PLANS AND DOCUMENTS
referred to in the PDA
DEVELOPMENT APPROVAL

Approval no: DEV2017/901

Riverside Celestino

ROL1 Traffic Impact Assessment

Figure 11: Bus turnaround (Calibre 13/03/19)

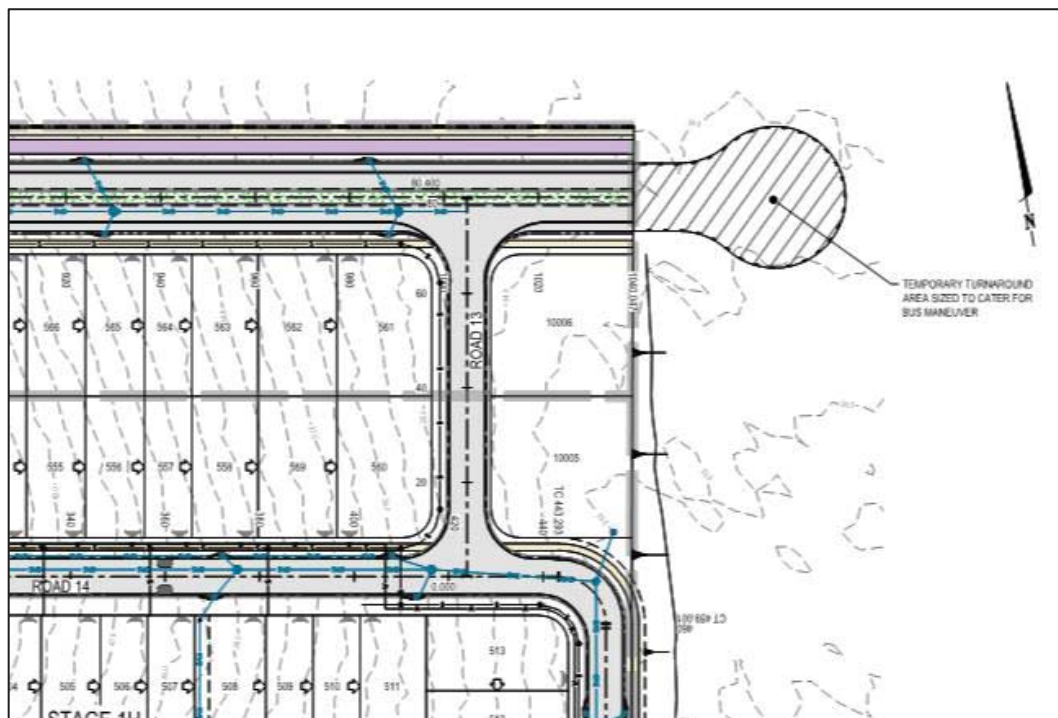
4. b) Temporary bus turn around area show shows the extent of kerb and channel.	Refer Figure 11
4. c) Discussions should occur early with EDQ and TransLink on any potential bus route.	Refer Section 3.3
